Response to Biodiversity Conservation Division
advice on Response to Submission report

Valley of the Winds – Response to BCS Advice on RtS

ACEN Australia

Figure 18: Spring survey effort - Spring flora survey within Girragulang Road cluster

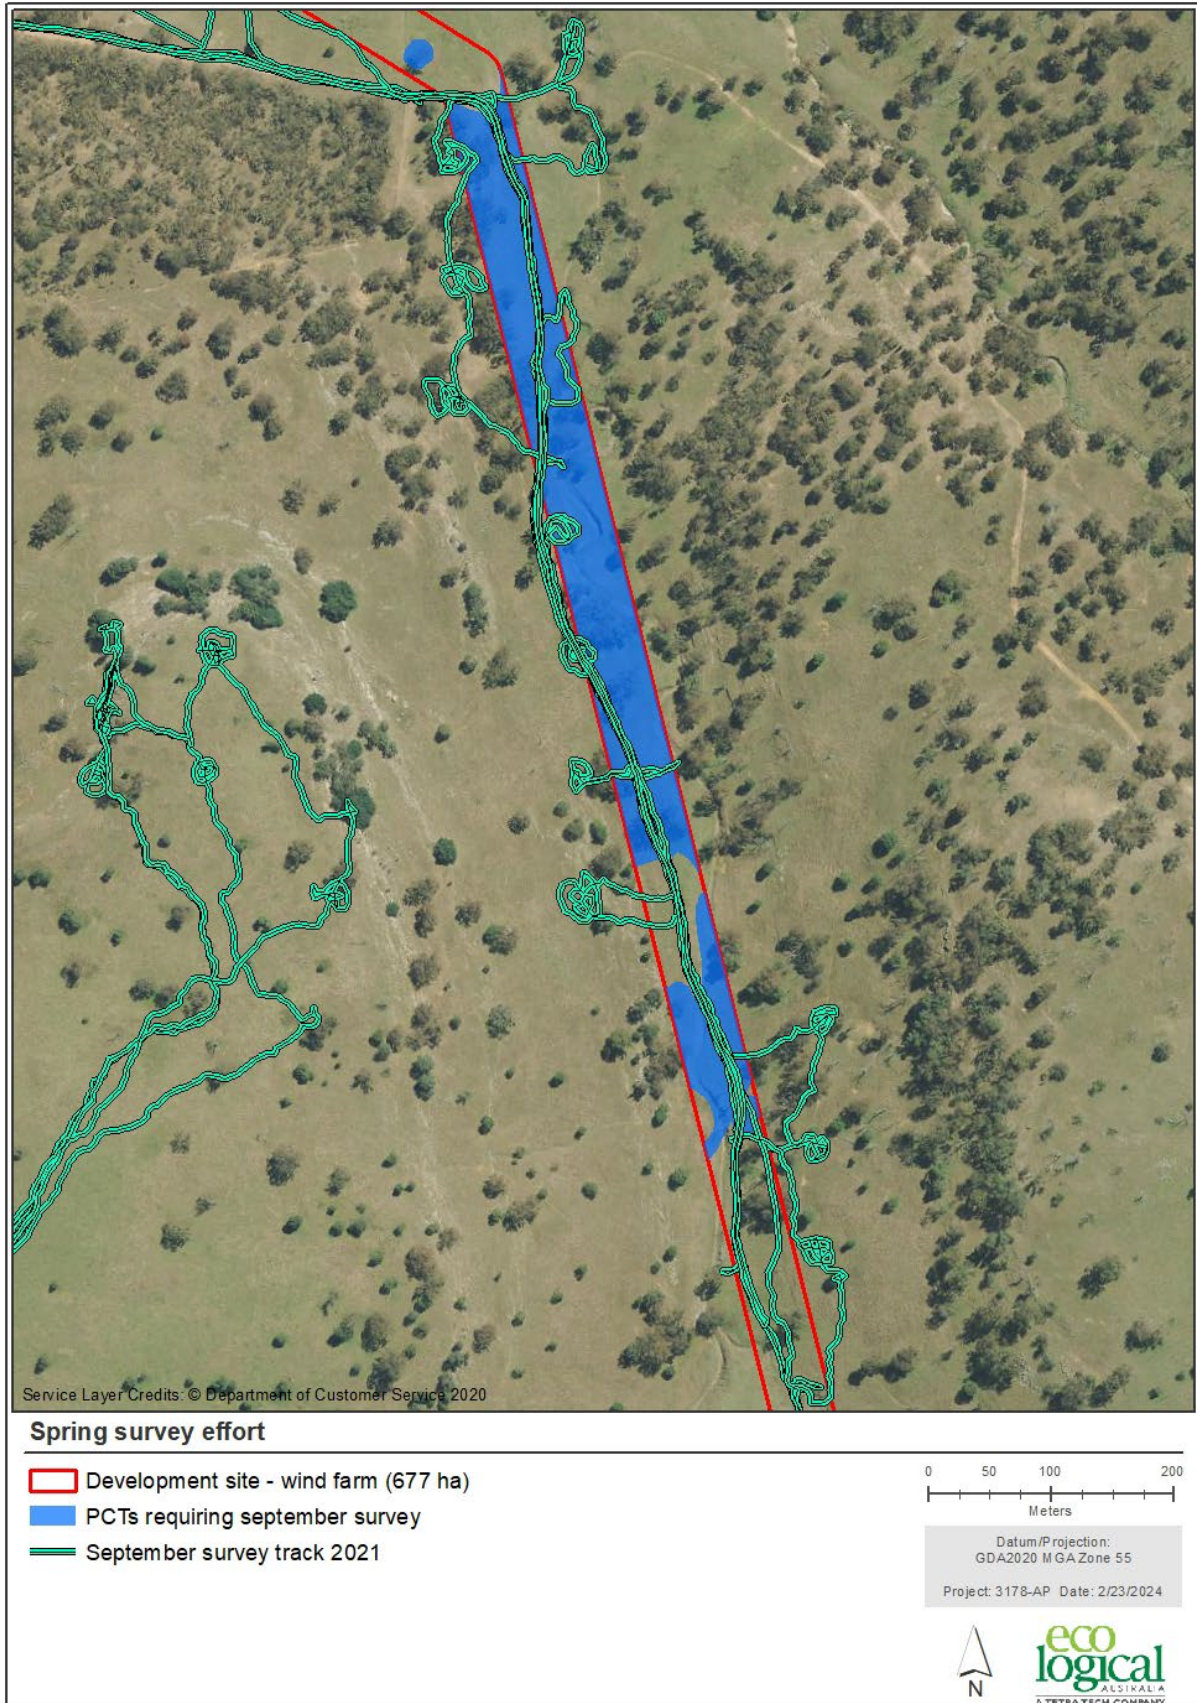
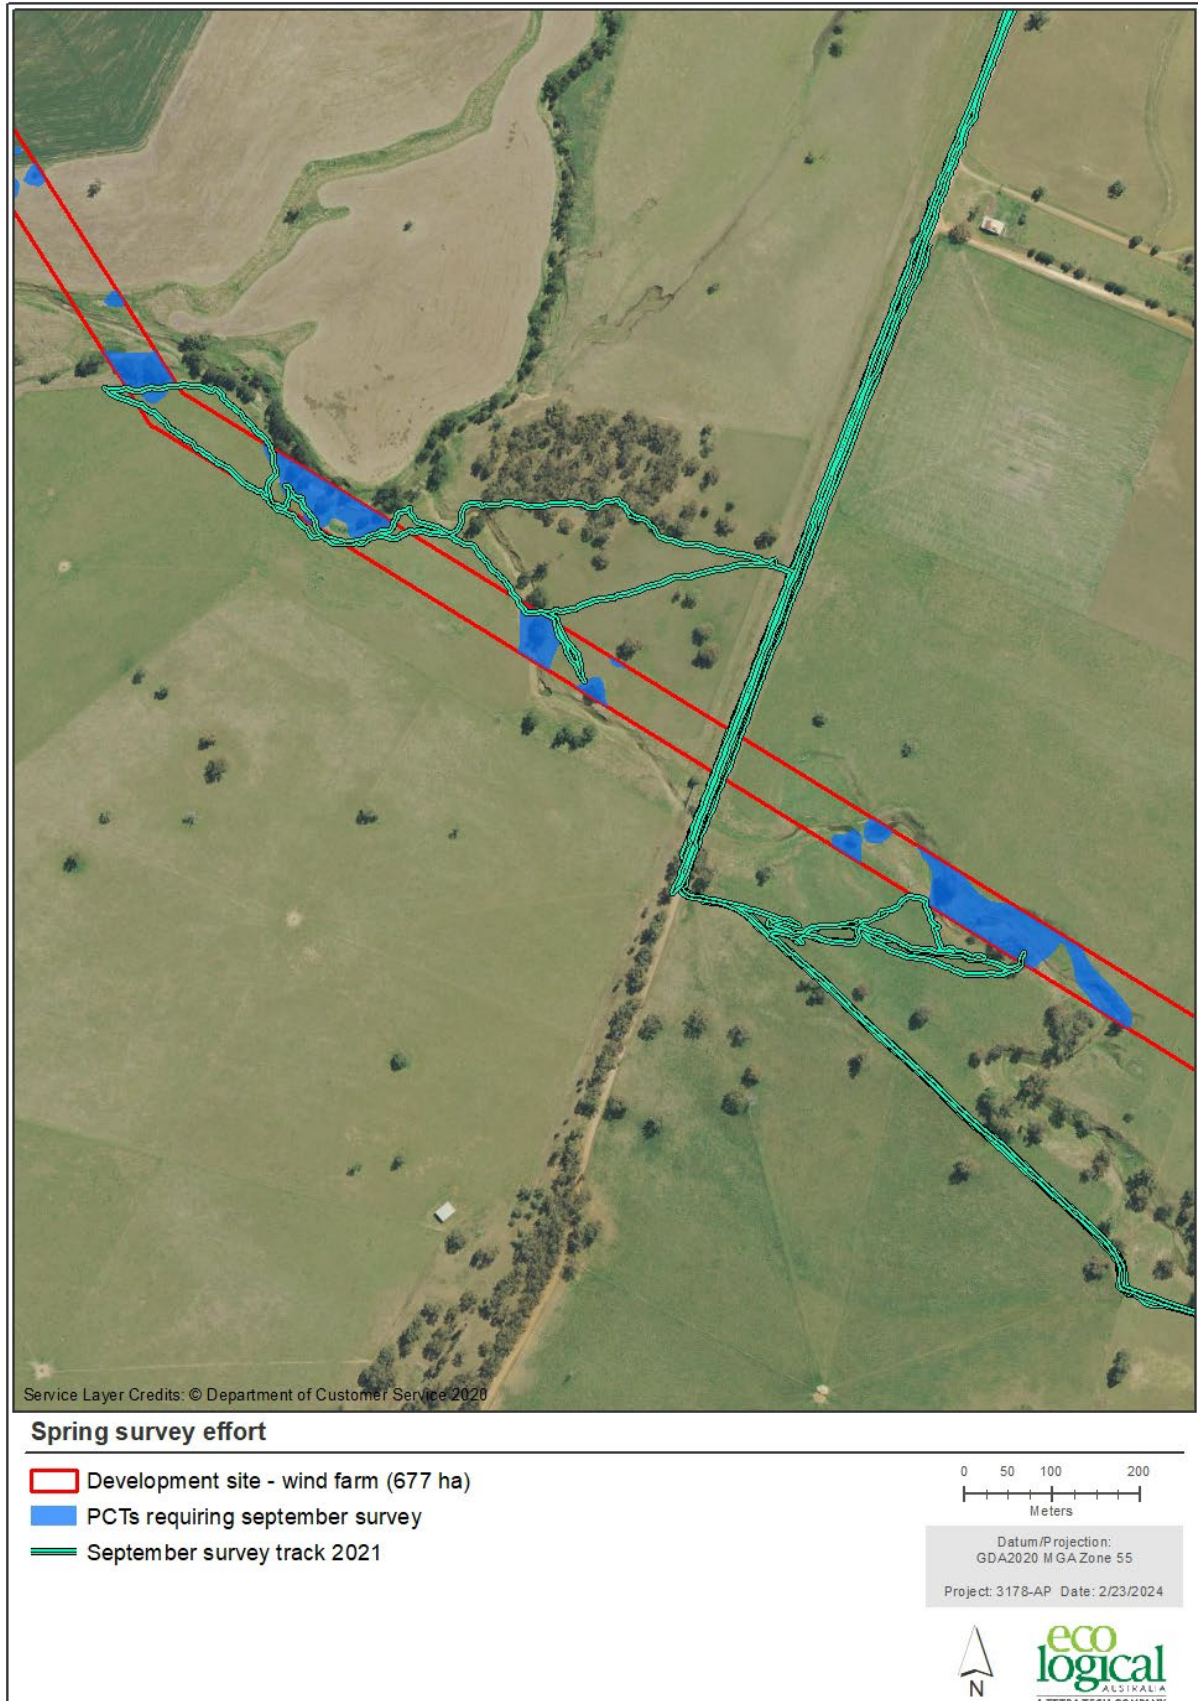
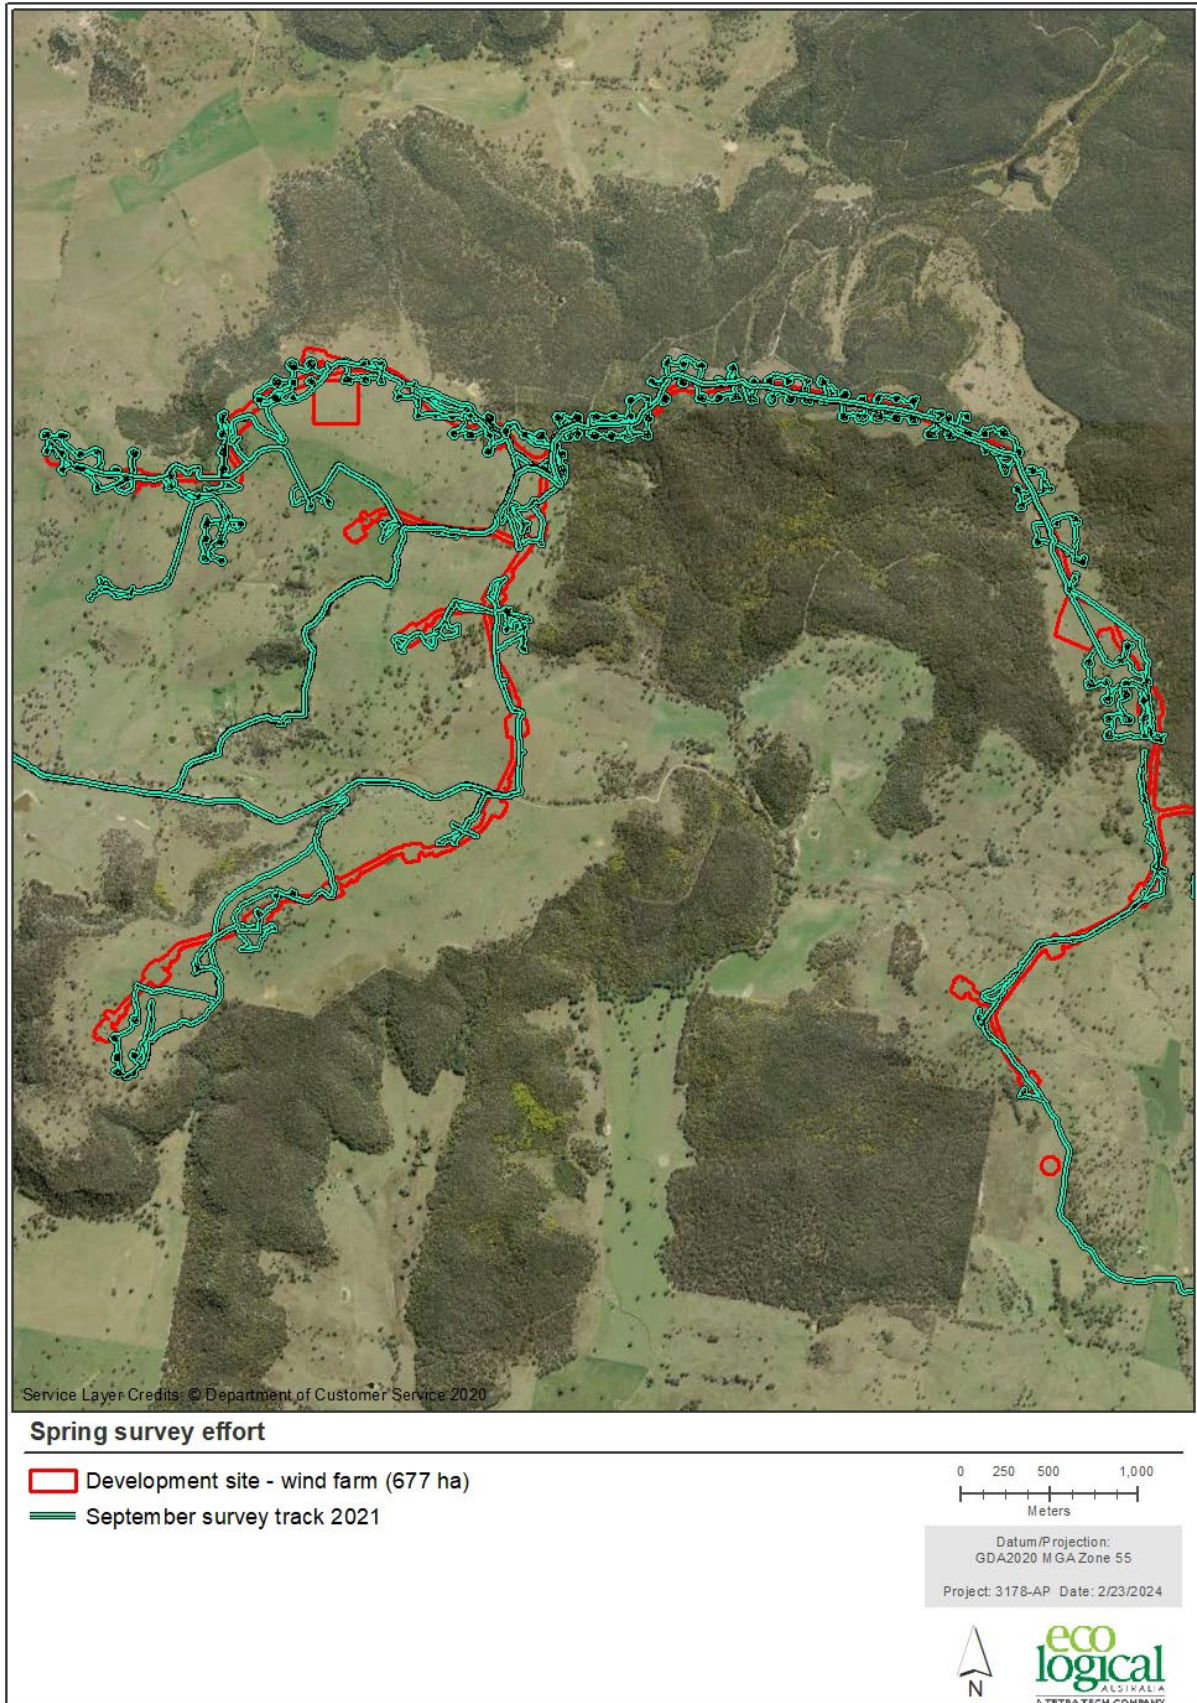
23.1 Provide a spatial file of the grid points which were surveyed during targeted flora survey and display these grid points within the BDAR.

ELA has prepared several maps of the areas required for survey (Figure 18 to Figure 20). In addition to the minimum required effort, ELA also conducted surveys more broadly in spring for threatened flora (outside of associated PCTs). These areas are shown on Figure 20 to Figure 22. The spring survey effort significantly exceeds the requirements of the BAM, and no further survey is required.

Figure 24: Additional harp trapping January 2024 - survey results

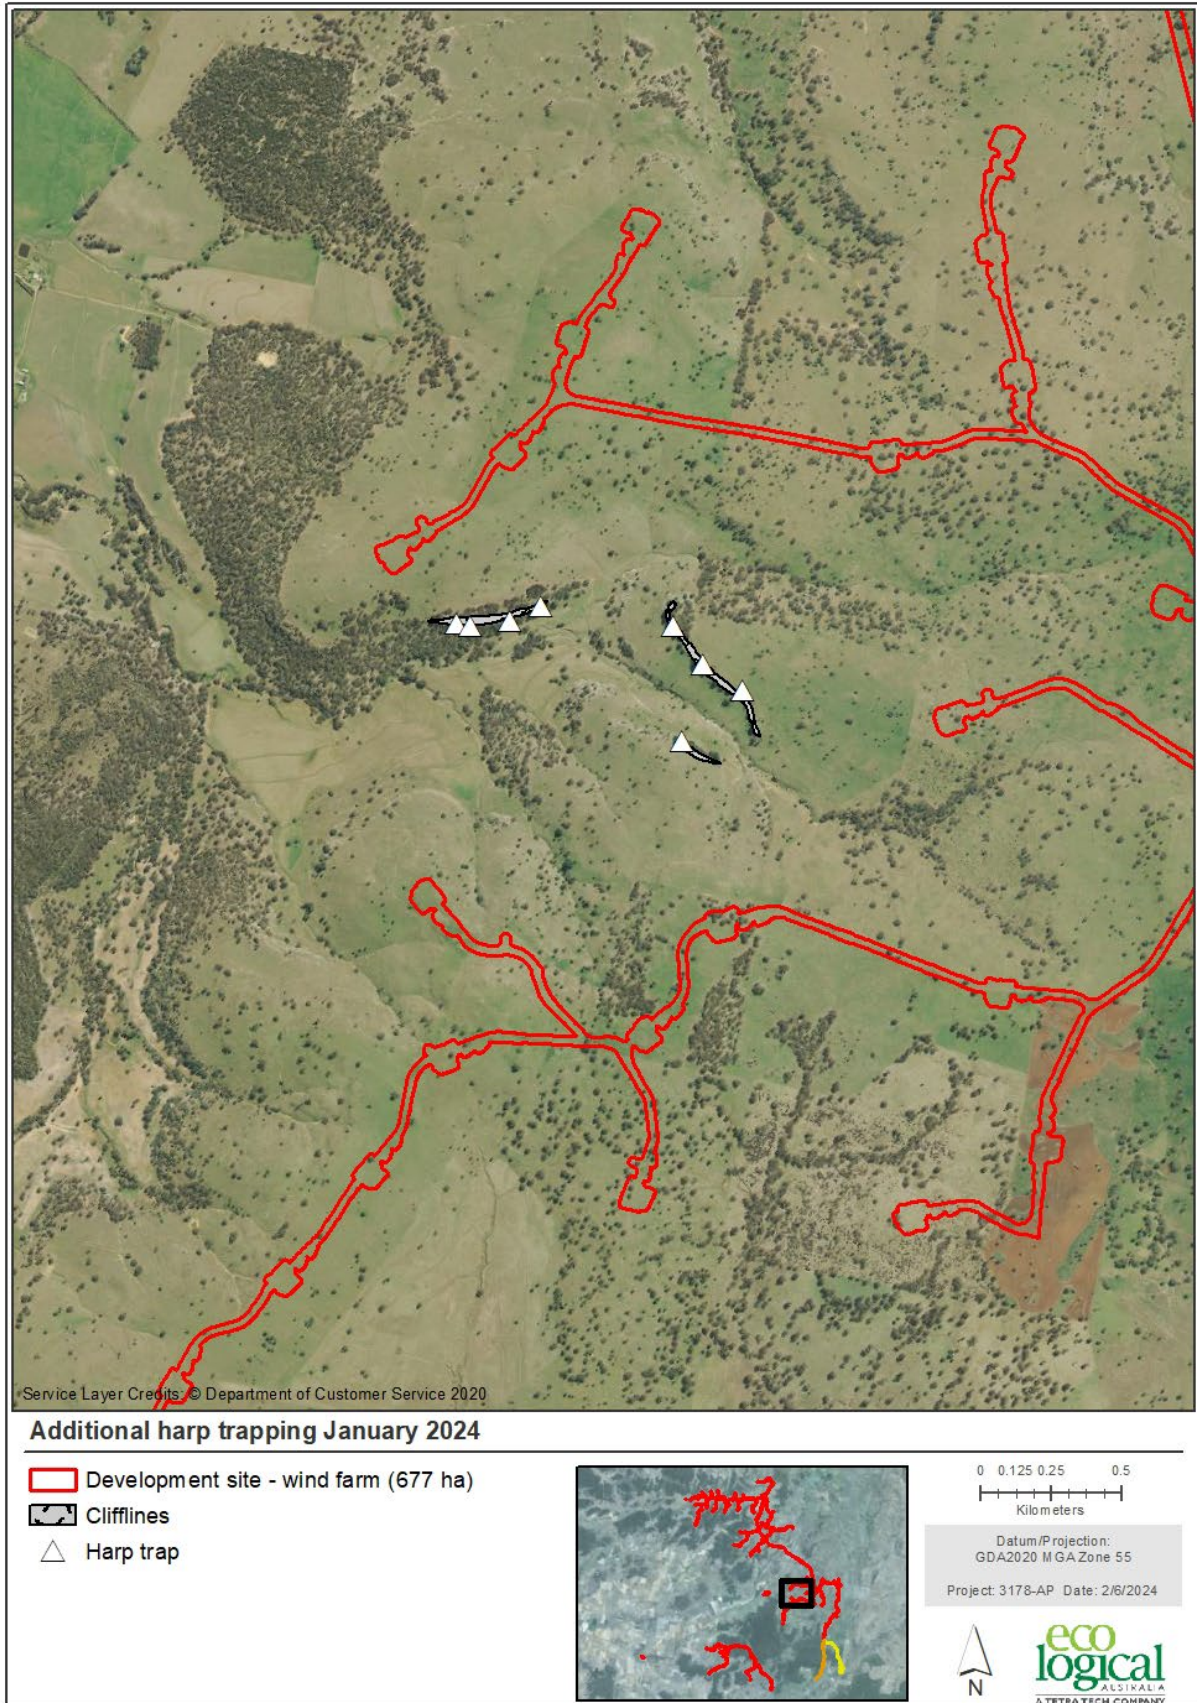
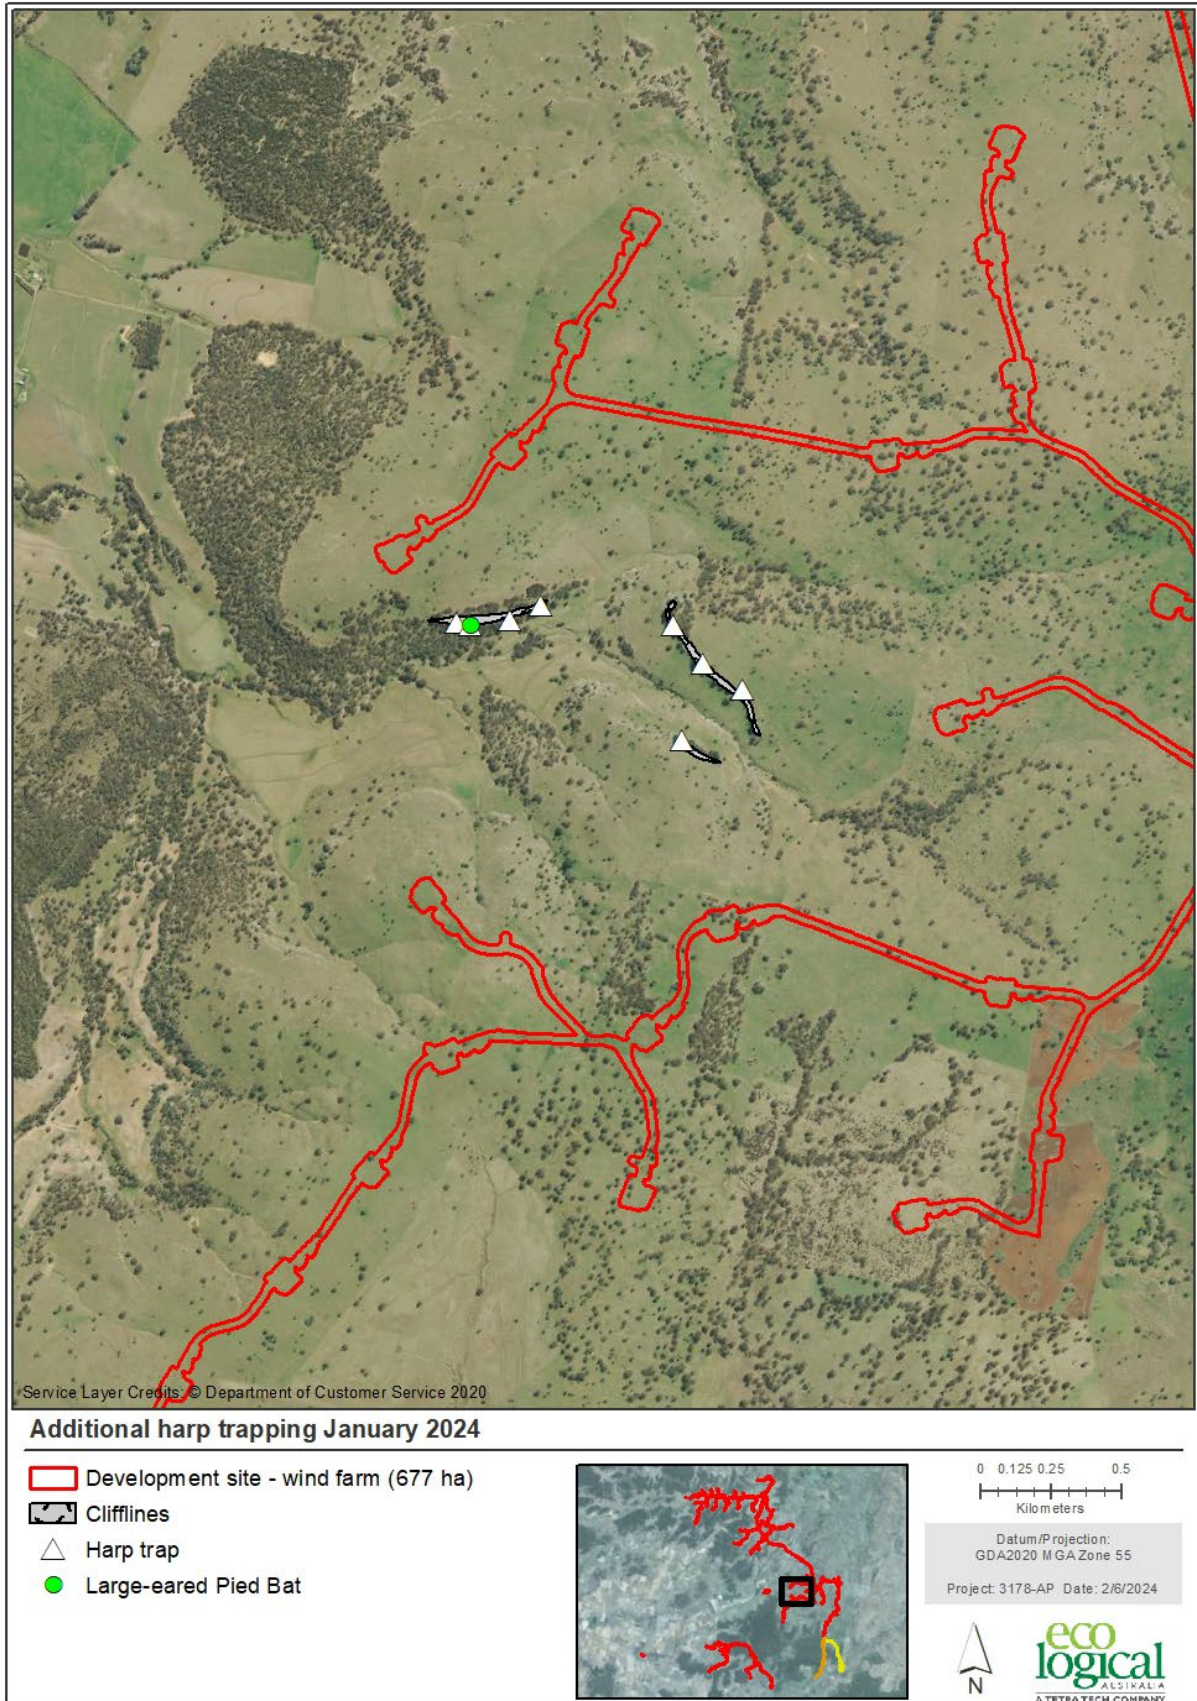
1.1 Conduct additional harp trapping surveys for threatened microbats at turbine clusters which are proximate to potential breeding habitat, in accordance with the threatened microbat survey guidelines.

One Large-eared Pied Bat (*Chalinolobus dwyeri*) was trapped during survey. This species is listed as Vulnerable under the BC Act and Endangered under the EPBC Act. Details surrounding the age and sex of this trapped individual are discussed further in the section below. The location of the trapped Large-eared Pied Bat is provided in Figure 24.

One Large-eared Pied Bat was trapped in NEW_HARP_07 on 24 January 2024. The location of the trapped microbat is shown above in Figure 1. NEW_HARP_07 was set in front of a small sandstone overhang with a roughened ceiling and numerous crevices (Photograph 5). The overhang was approximately 4 m by 3 m deep with the ceiling being 1.2 m high at the entrance and 0.2 m high at its lowest. It was inspected for microbats and evidence of microbats on 22 January 2024 and again on 25 January 2024 by ELA Ecologist Sophie Montgomery. No evidence was observed.
